[Docket No. FAA-2011-0994; Directorate Identifier 2010-NM-143-AD]

Airworthiness Directives; Bombardier, Inc. Model CL-600-2C10 (Regional Jet Series 700, 701, & 702), CL-600-2D15 (Regional Jet Series 705), and CL-600-2D24 (Regional Jet Series 900) Airplanes

ACTION: Notice of proposed rulemaking (NPRM).

Figure 1
LH side shown
RH side opposite

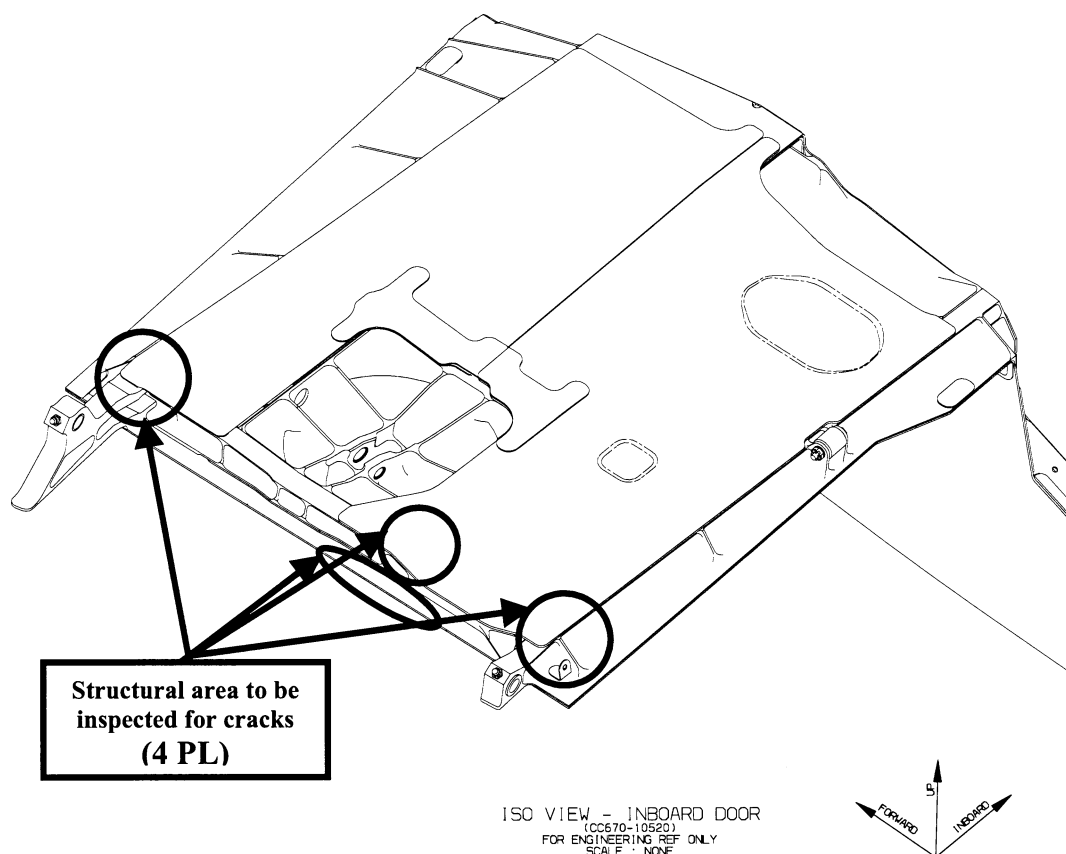
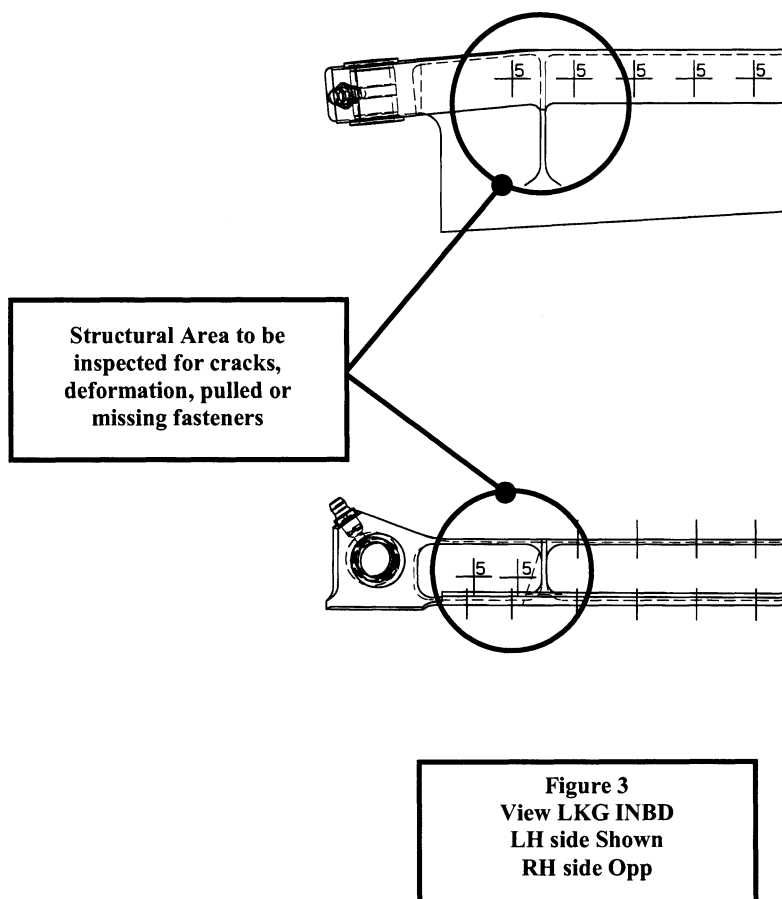
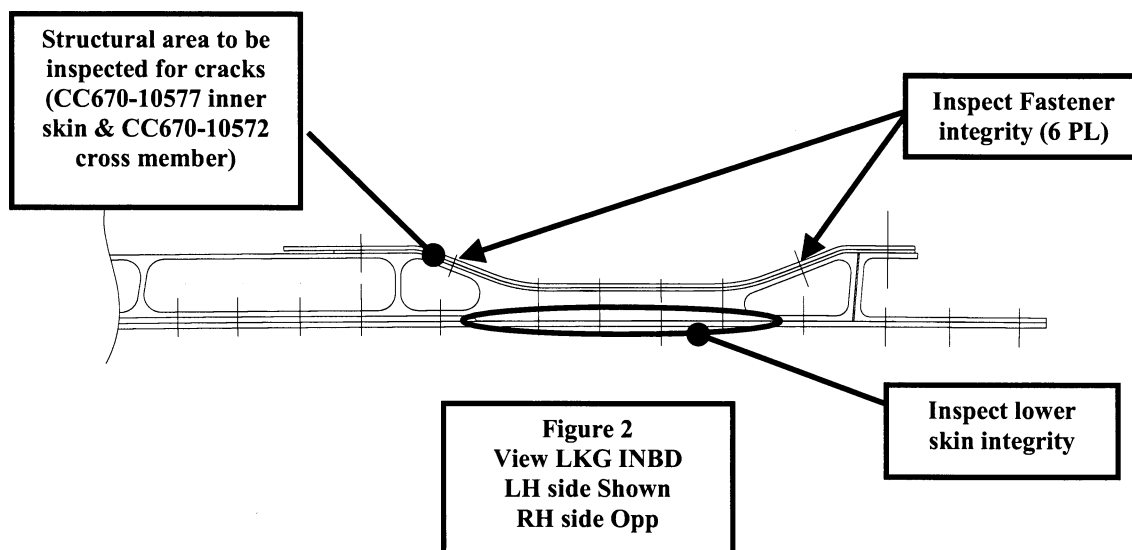
(1) Inspect the cross member, P/N CC670–10572, of the MLG door lower panel for cracking or deformation, in accordance with Figure 2 of this AD.

(2) Inspect the inner skin, P/N CC670–10577, of the MLG door lower panel at the cross member (P/N CC670–10572) for cracking or deformation, or pulled or missing fasteners, in accordance with Figure 2 of this AD.

(3) Inspect the outer skin, P/N CC670–10574, of the MLG door lower panel at the cross member (P/N CC670–10572) for cracking or deformation, or pulled or missing fasteners, in accordance with Figure 2 of this AD.

(4) Inspect the forward member, P/N CC670–10570, and aft member, P/N CC670–10571, of the MLG door lower panel for cracking or deformation, or pulled or missing fasteners, in accordance with Figure 3 of this AD. Figures 1 through 3 of this AD follow.
